**TOWN OF OCEAN RIDGE
PLANNING & ZONING REGULAR MEETING
AGENDA**

To: Planning & Zoning Board Members
From: Corey O’Gorman, Town Planner
Meeting Date: April 16, 2024
Subject: 3 Hudson Avenue – Development Plan Review

PLAN REVIEW REPORT
3 Hudson Avenue
March 04, 2024
REVIEW OF REVISIONS – March 19, 2024

**Re: 3 Hudson Ave
Development Plan Review
Engenuity Group Project No. 00020.10**

SP-1

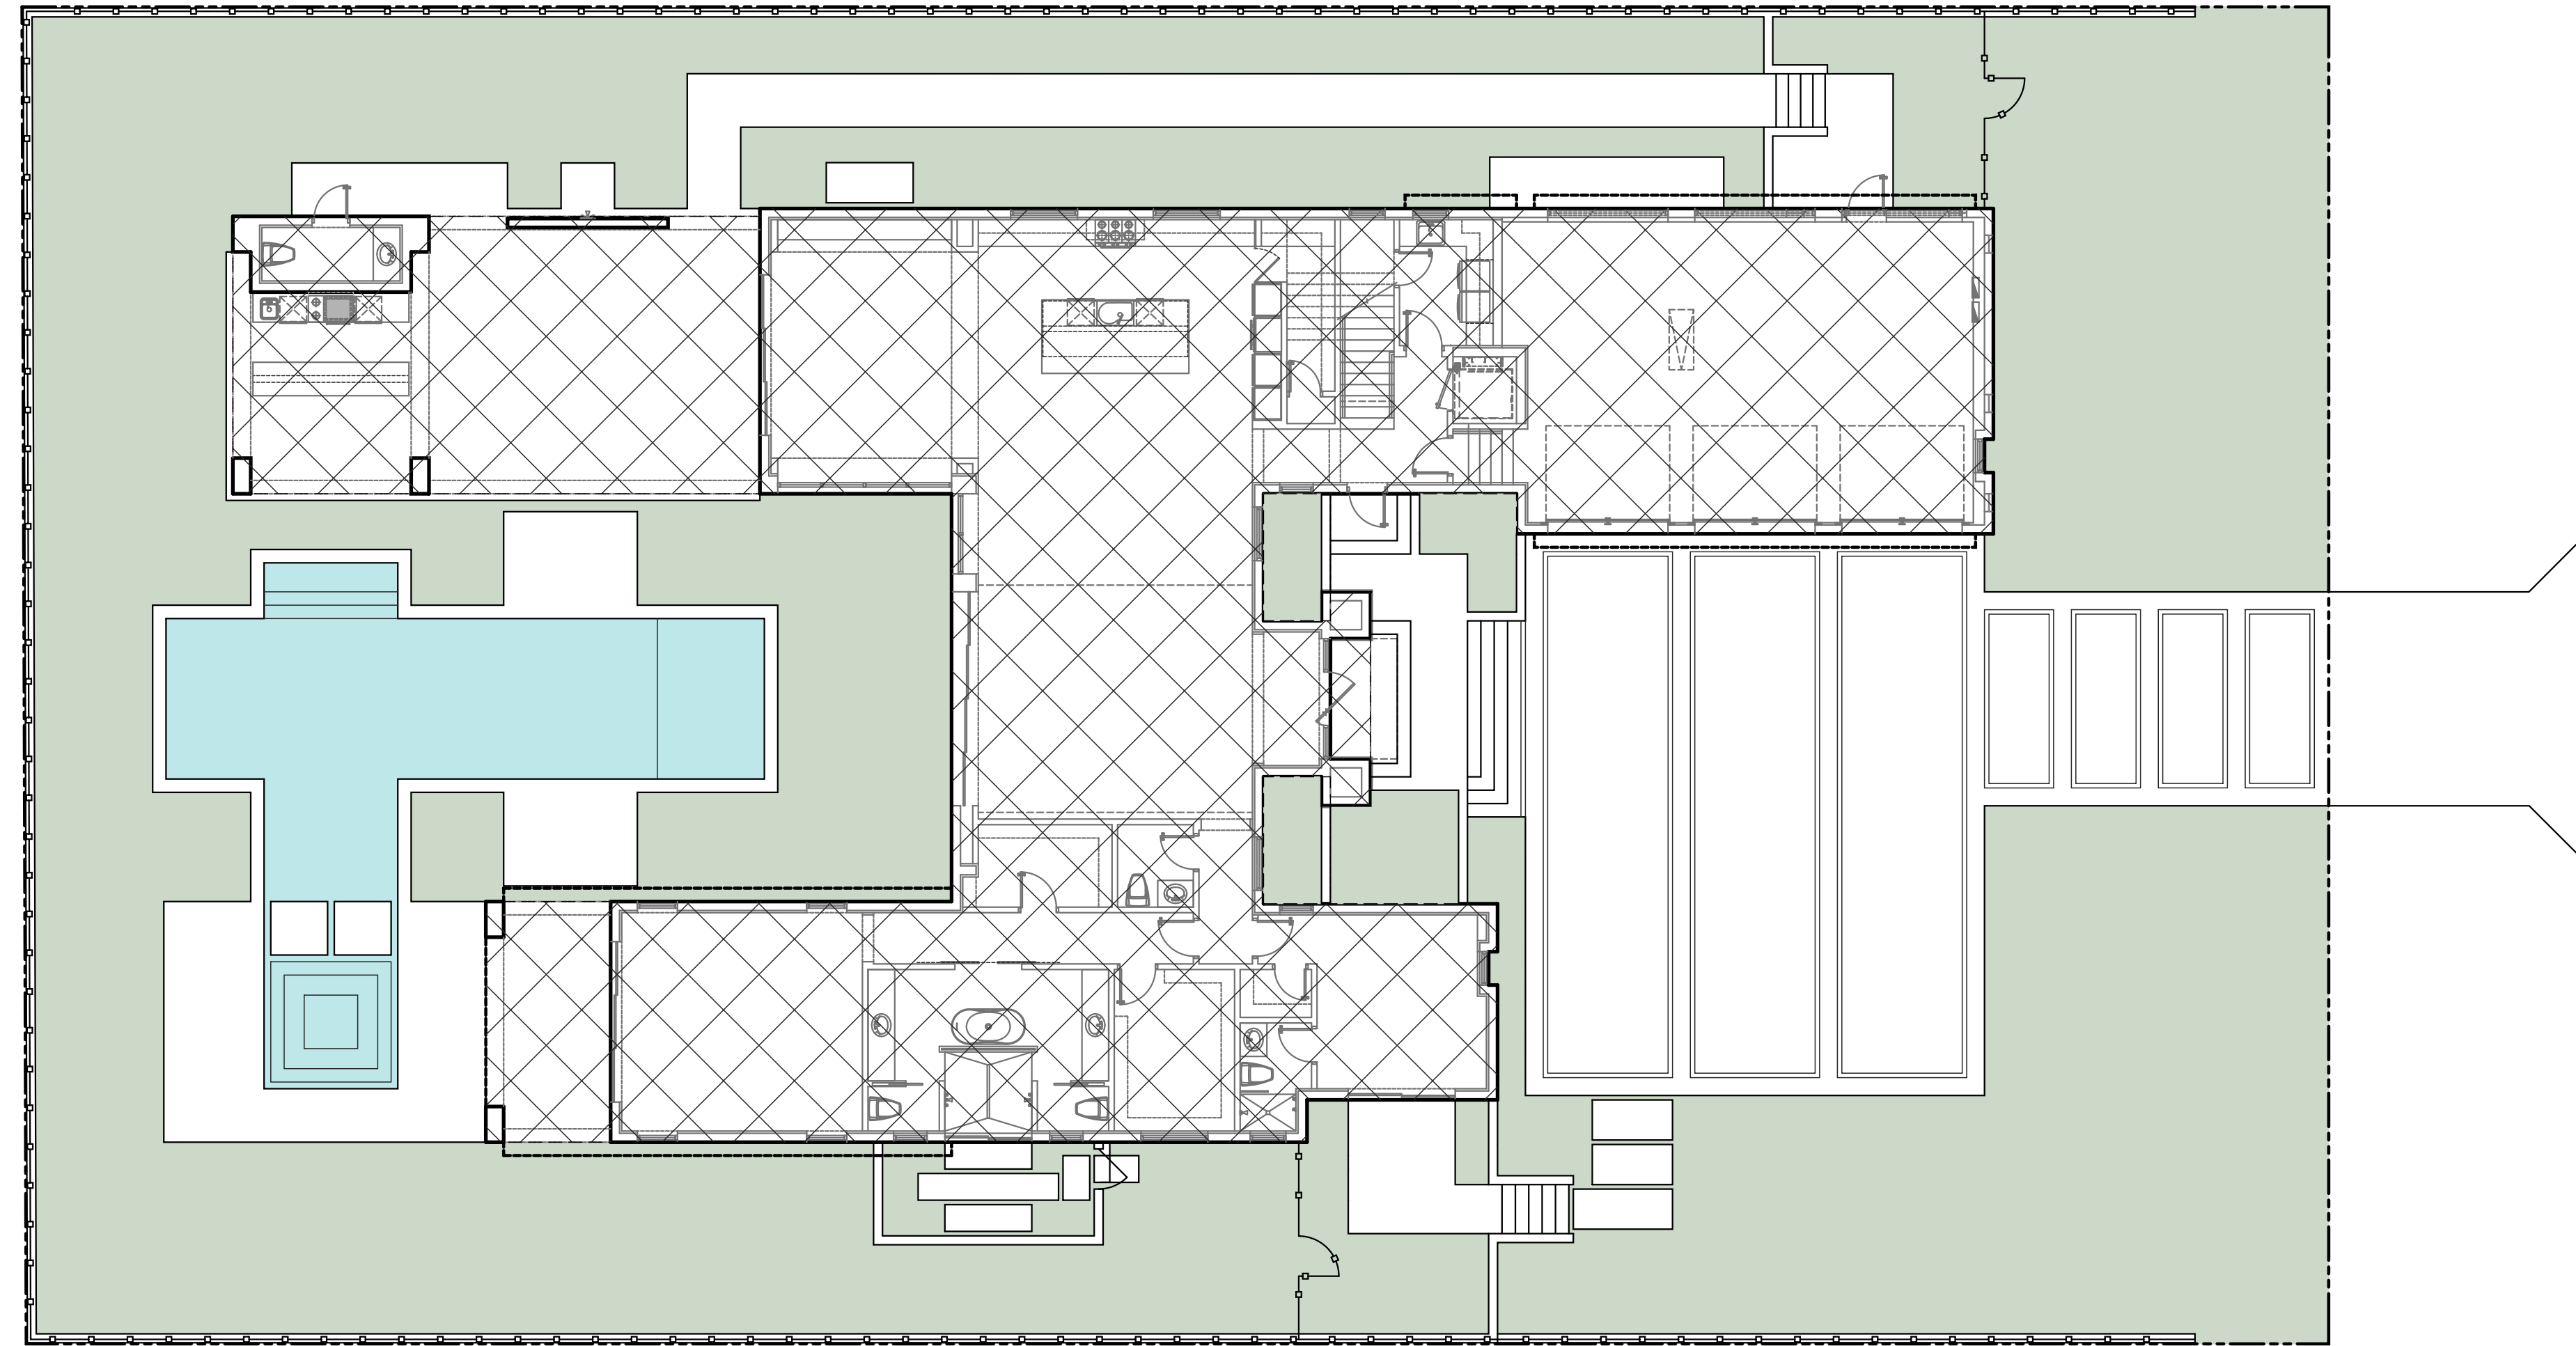
~~Comment: The data tabulation on SP 1 and SP 2 show a total FAR is 36.3%. In addition, data tabulations shows the lot area of 17,236 square feet and a total square footage for FAR calculation of 6288 which is 36.48% of the lot area which exceeds the maximum allowable. Based on a total lot area of 17,236 the maximum floor area is 6,204.96 square feet. Please revise accordingly and provide the total floor area to comply with this section of the code. Comment addressed.~~

~~Comment: This home includes five (5) bedrooms, thus requiring two (2) garage spaces dimensioned (10 x 20) and three (3) exterior spaces (measured at 9 x 18). Although there appear to be sufficient spaces to comply with the code, they are not dimensioned. Please revise site plan Sheet SP 1 show to include all required spaces fully dimensioned. Comment addressed.~~

P-5

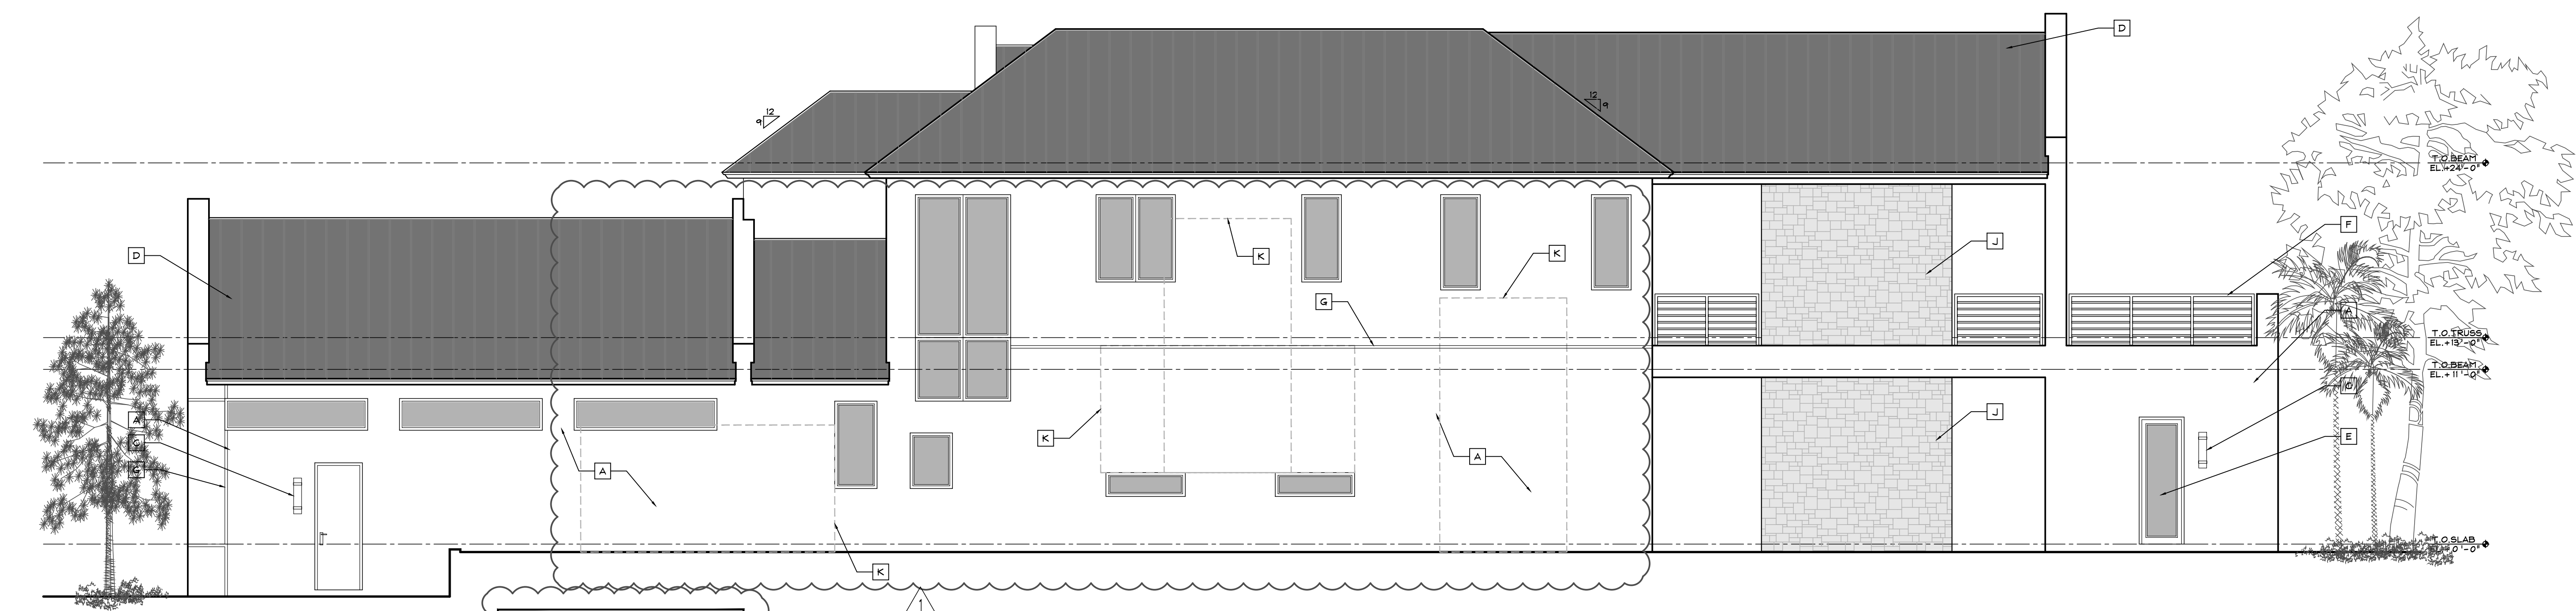
~~Comment: Sheet P-4 includes window calculation for the north elevation and an 8 x 16 diagram for wall articulation requirements, but does not include calculations or diagram for the south, east, and west elevations. Please revise sheets P-4 and P-5 to show the window calculation and the 8x16 diagram on all facades of the building to comply with this requirement. Comment addressed.~~

LANDSCAPE PLAN

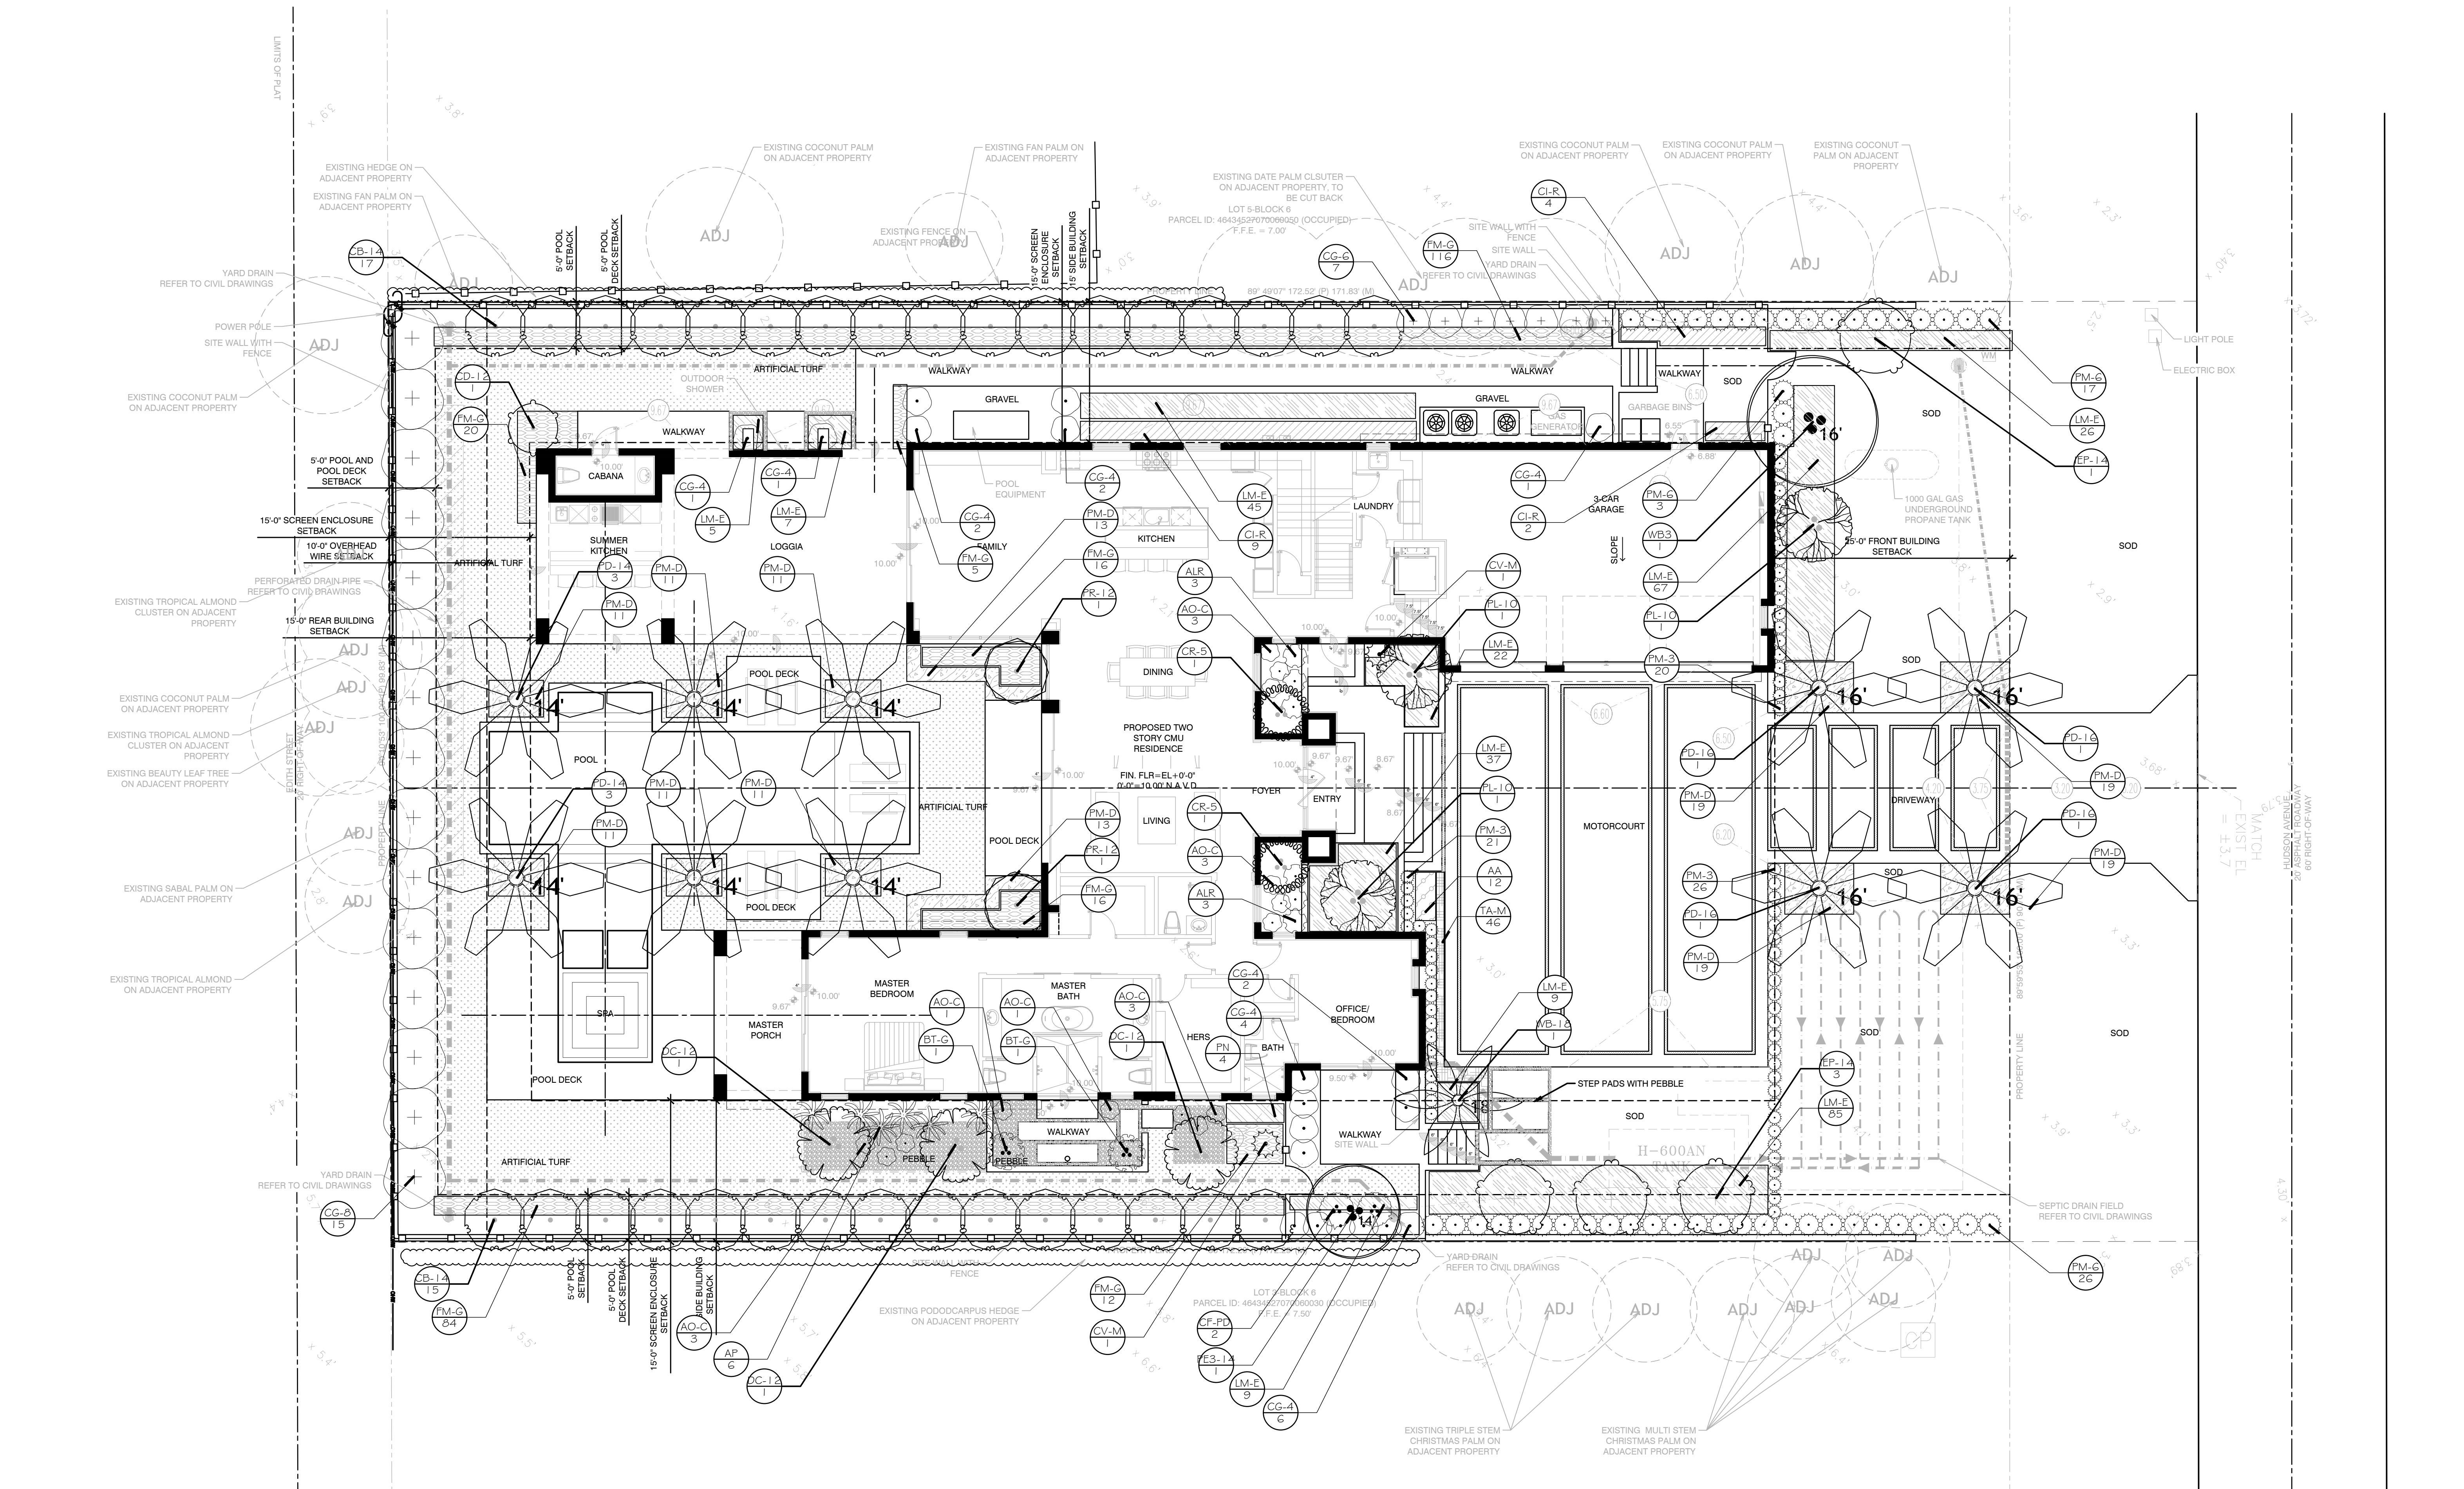
~~Comment: Sheet L-2 shows proposed artificial turf in the rear and sides of the property but does not provide a calculation. Please provide calculation for the proposed artificial turf. Comment addressed.~~
